PSLTR-00-0057

Dresden Nuclear Power Station, Units 2 and 3
Facility Operating License Nos. DPR-19 and DPR-25
NRC Docket Nos. 50-237 and 50-249

Subject: Request for an Amendment to Technical Specifications Section 3 /4.6.K, "Primary System Boundary" and Section 3 /4.12.C "Special Test Exceptions" and Request for Exemption from 10CFR 50.60, "Acceptance criteria for fracture prevention measures for lightwater nuclear power reactors for normal operation."

FIGURE 3.6.K-1

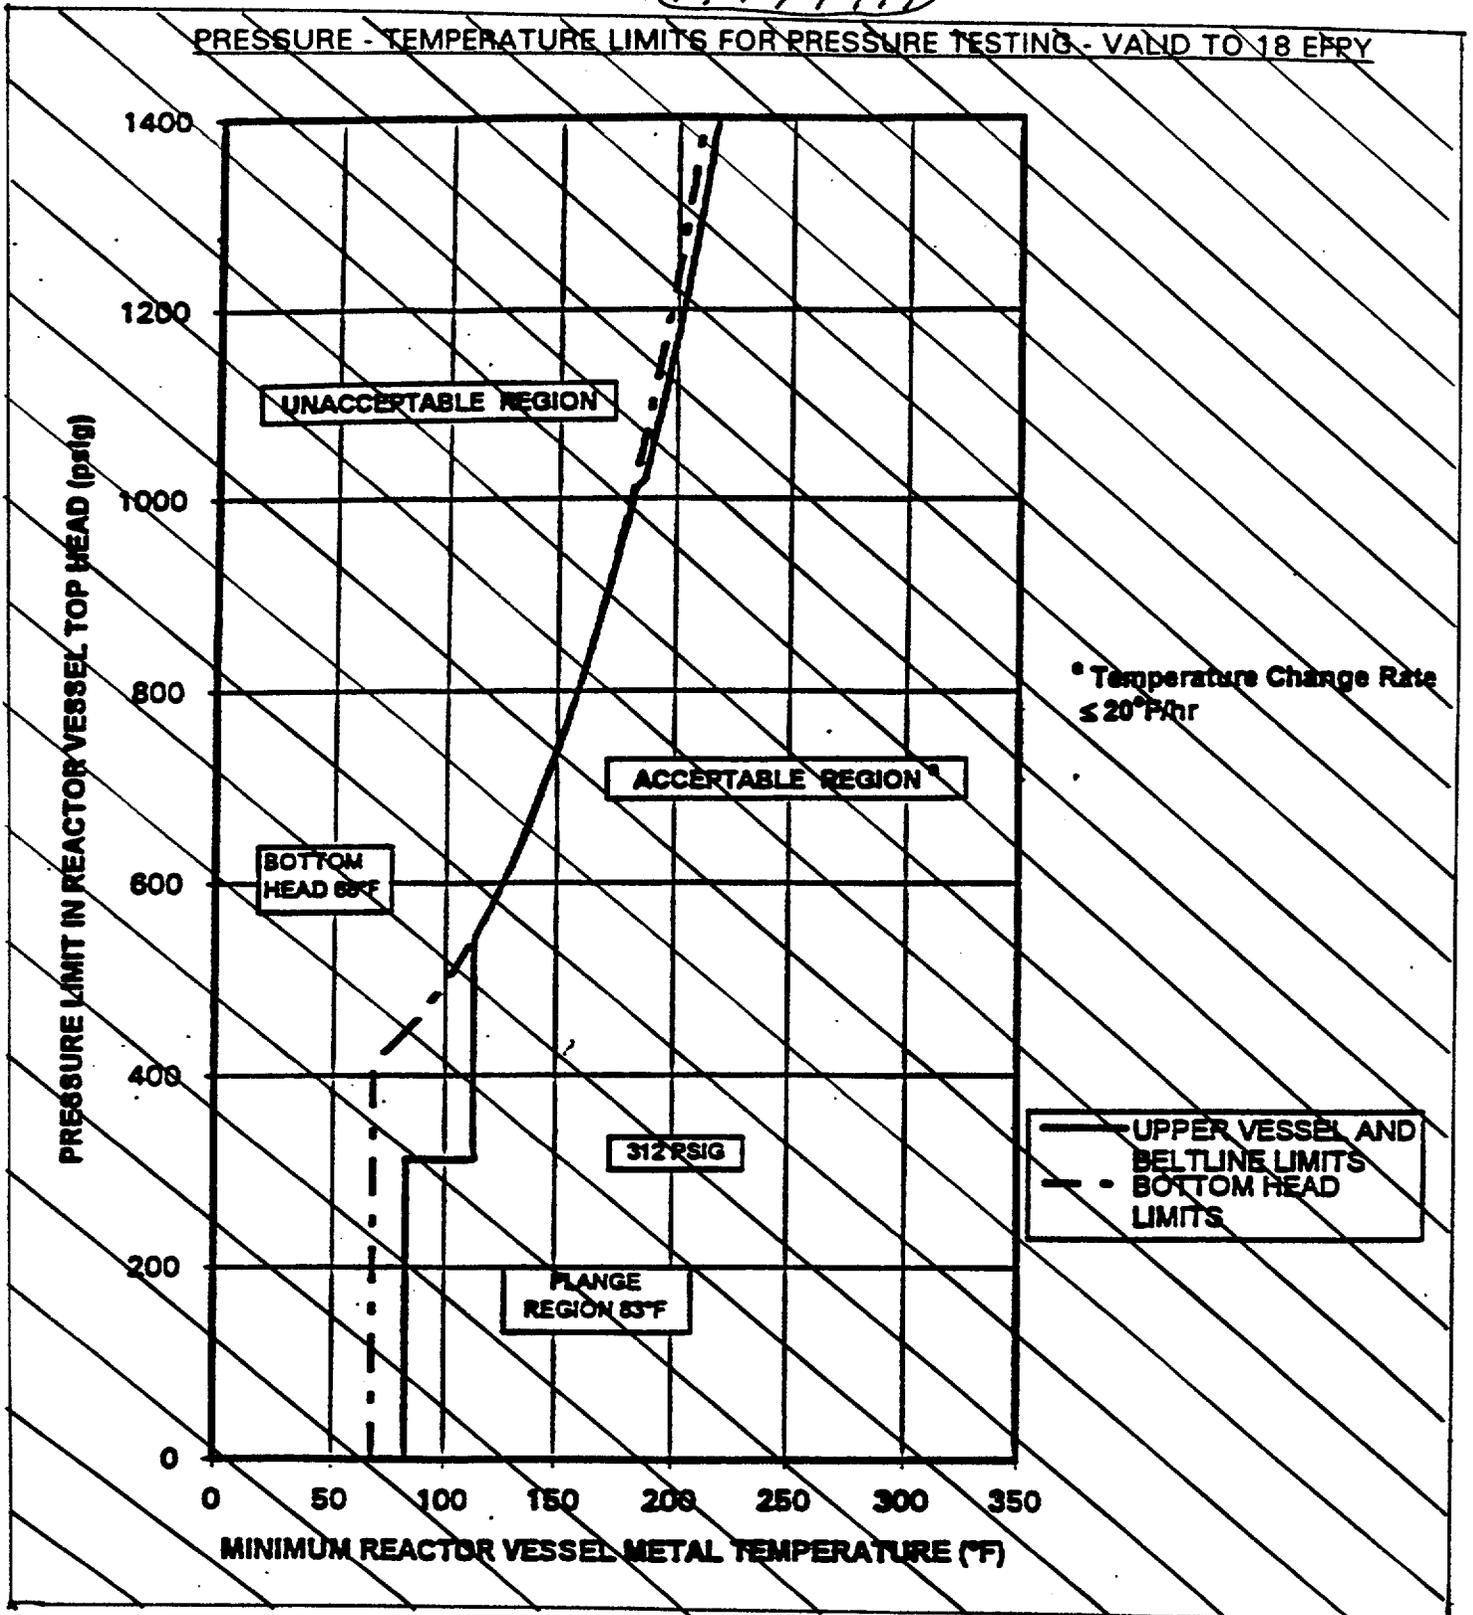
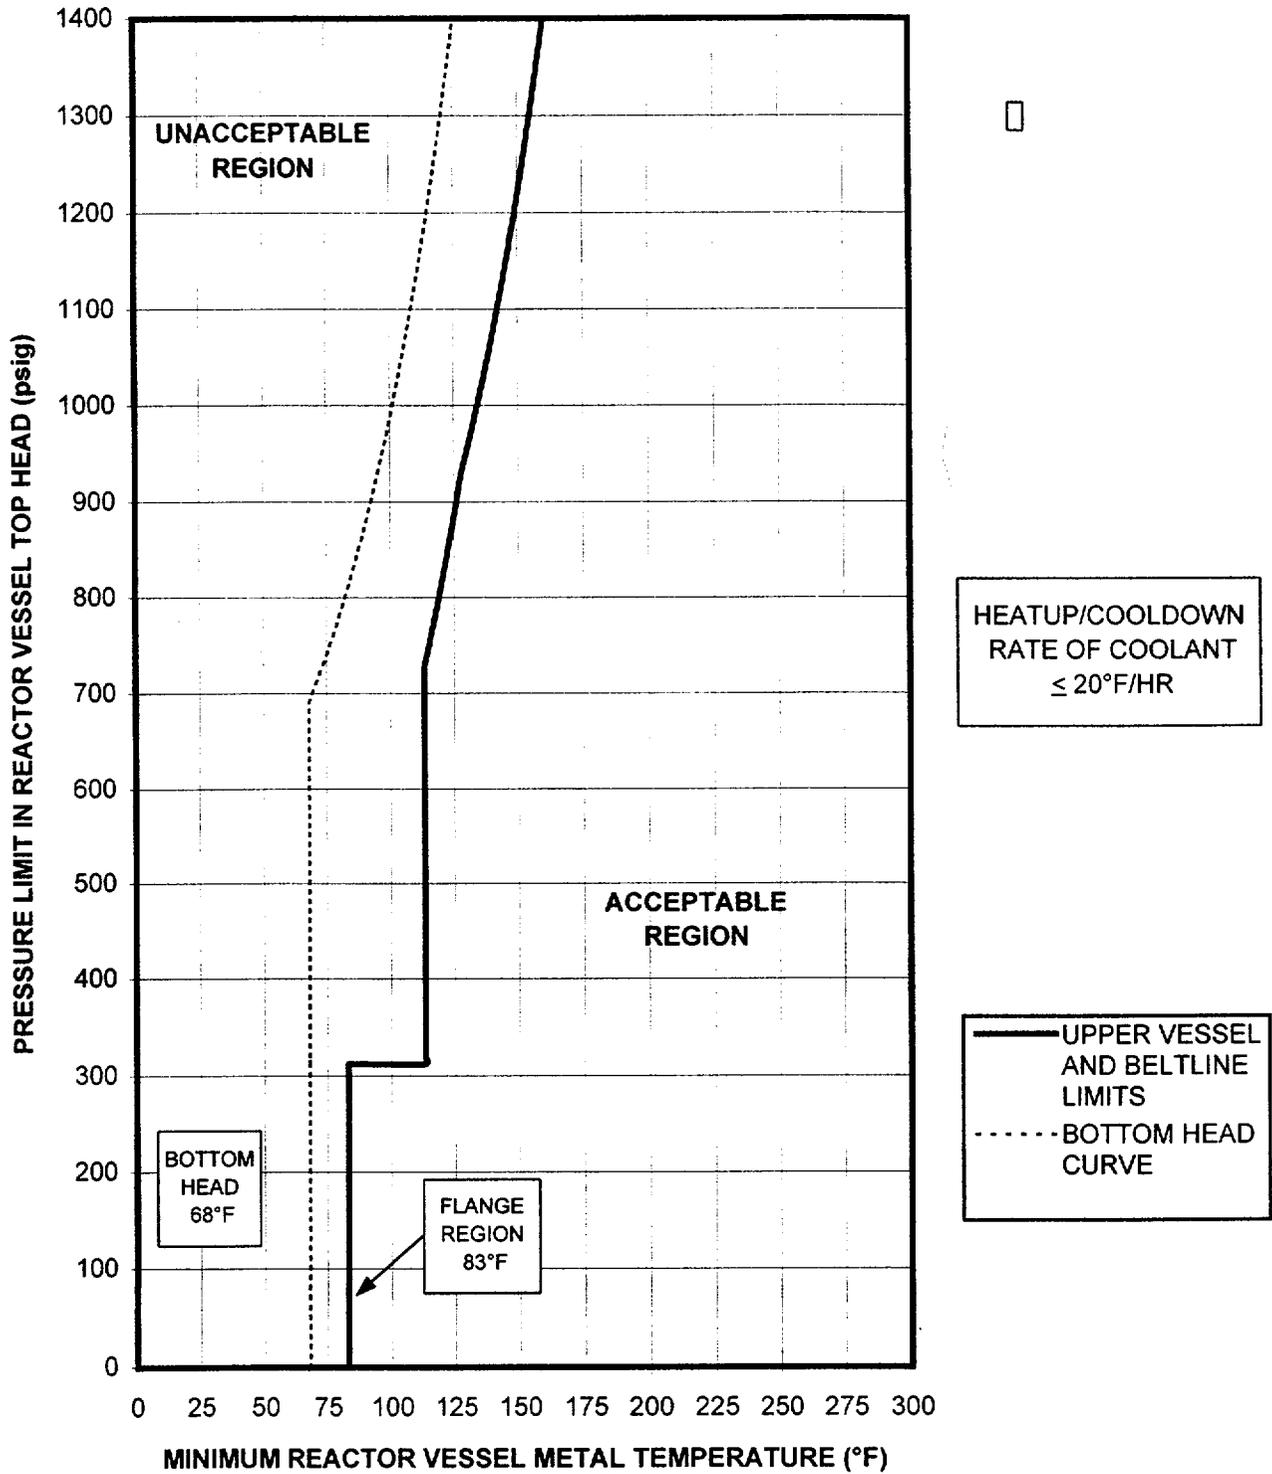
The proposed changes revise TS Figures 3.6.K-1 through 3.6.K-5, and delete the Special Test Exception for Inservice Leak and Hydrostatic testing operation. The proposed TS Figures 3.6.K-1 through 3.6.K-3 are bounding P-T curves for Unit 2 and Unit 3 RPVs.

a. The reactor vessel metal temperature and pressure shall be maintained within the Acceptable Regions as shown on Figures 3.6.K-1 through 3.6.K-3 with the rate of change of the primary system coolant temperature $\leq 20^\circ\text{F}$ per hour, or

Figure 3.6.K-1 through 3.6.K-3 are governing for applicable pressure testing with a maximum heatup/cool-down rate of 20°F/hour. ^{is}

PRESSURE - TEMPERATURE LIMITS FOR PRESSURE TESTING - VALID TO 32 EPY

FIGURE 3.6.K-2

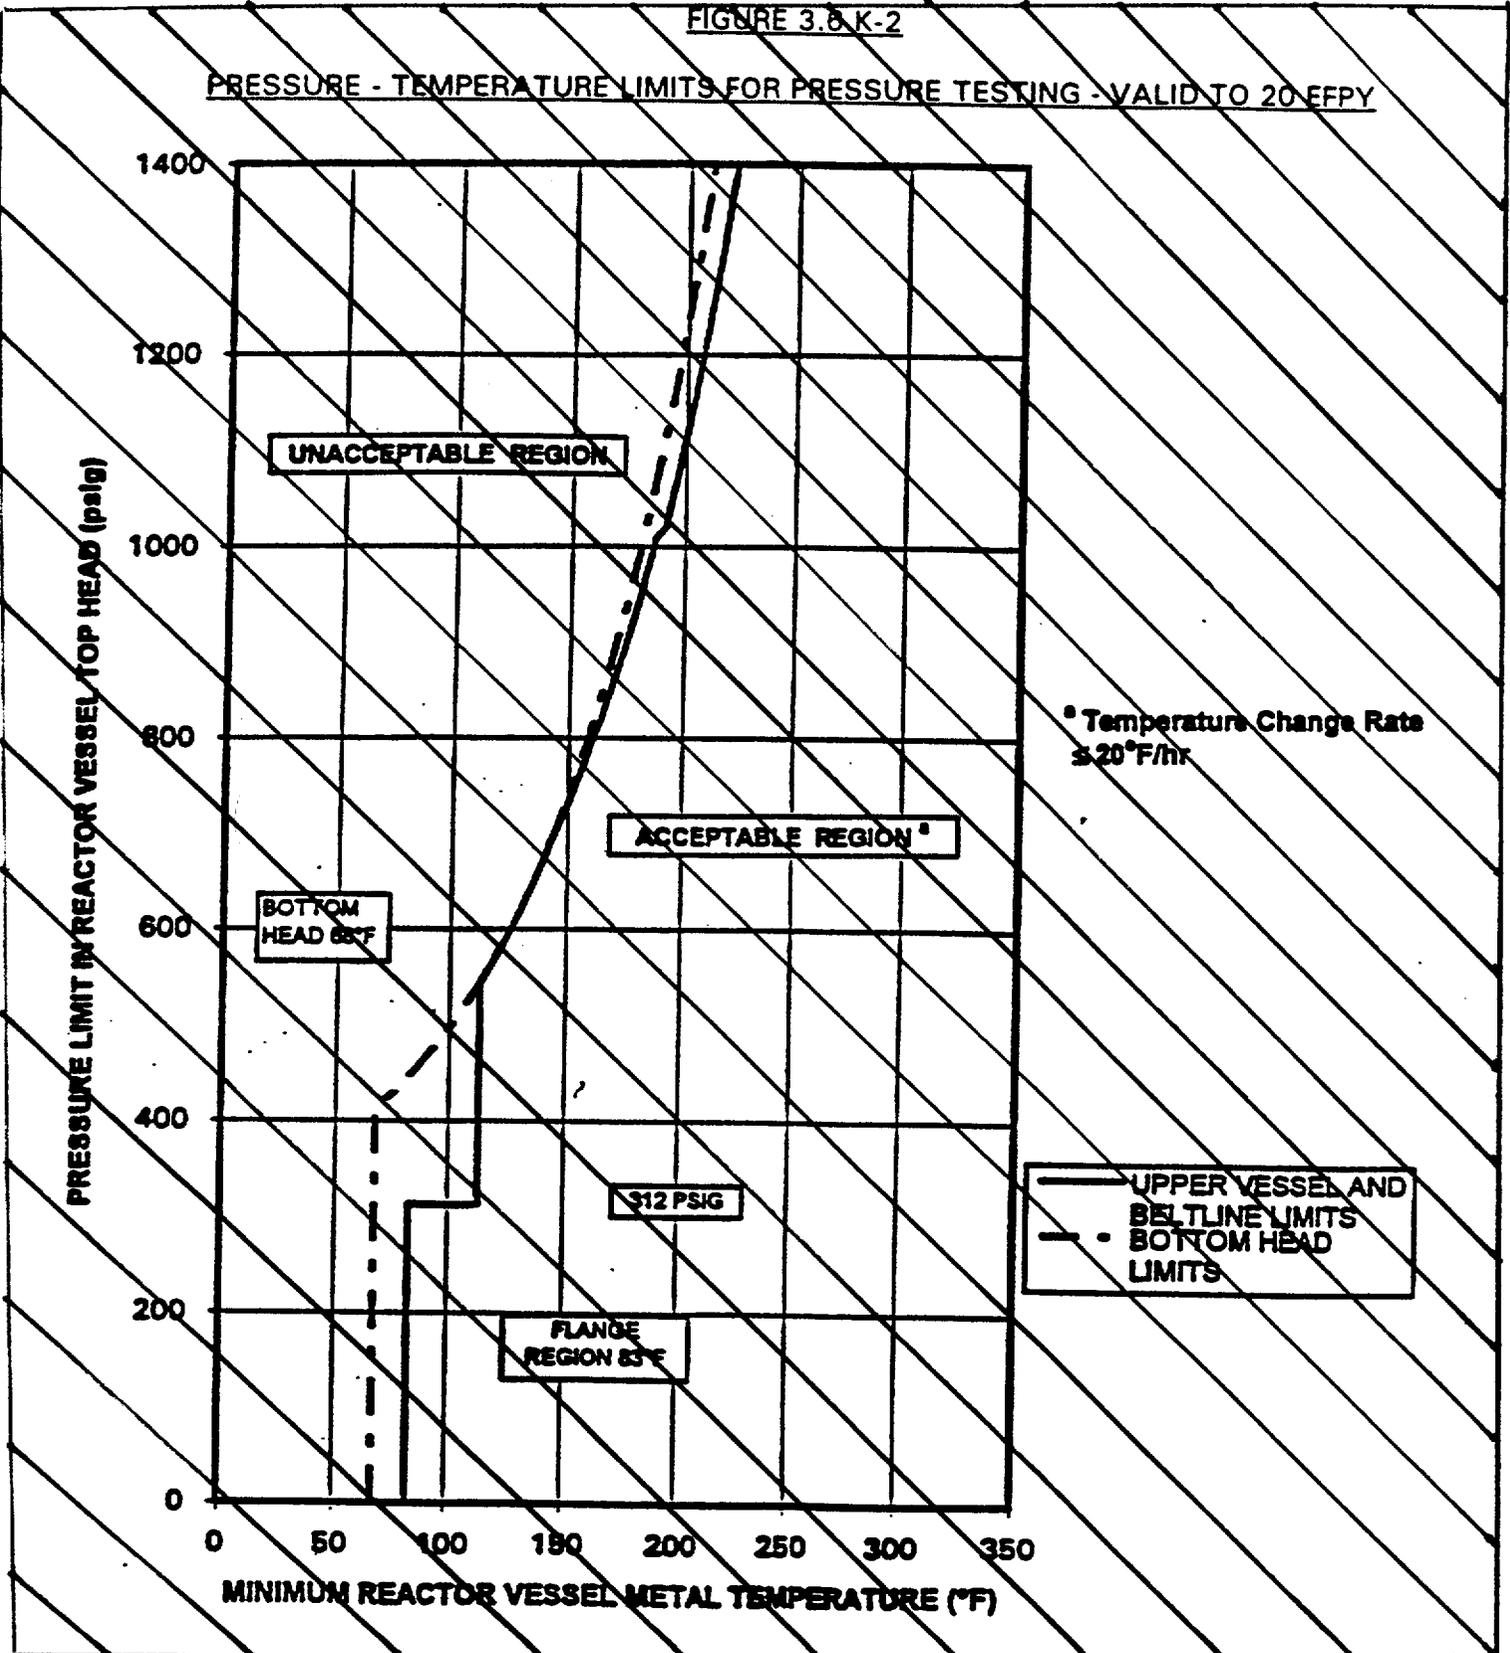
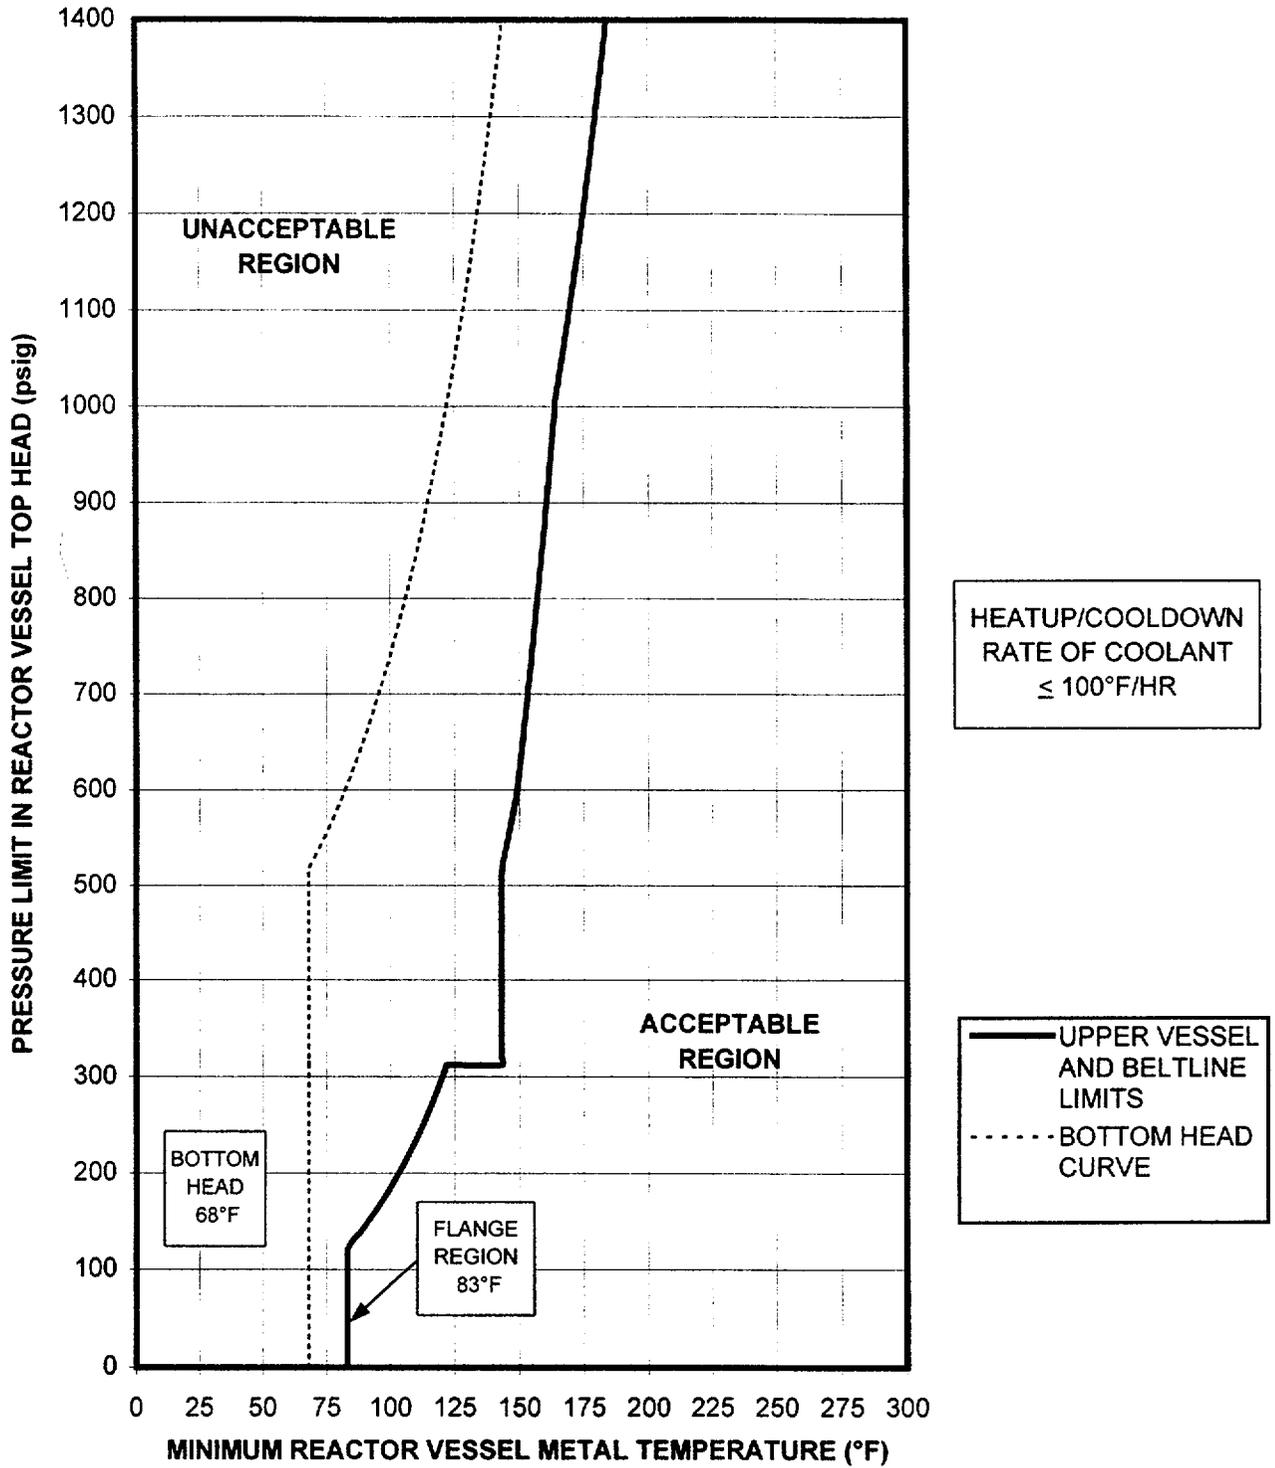
b. The rate of change of the primary system coolant temperature shall be $\leq 100^\circ\text{F}$ per hour when reactor vessel metal temperature and pressure is maintained within the Acceptable Regions as shown on Figure 3.6.K-2.

a. The reactor vessel metal temperature and pressure shall be maintained within the Acceptable Regions as shown on Figure 3.6.K-2, and

PRESSURE - TEMPERATURE LIMITS FOR NON-NUCLEAR
HEATUP/COOLDOWN - VALID TO 32 EFY
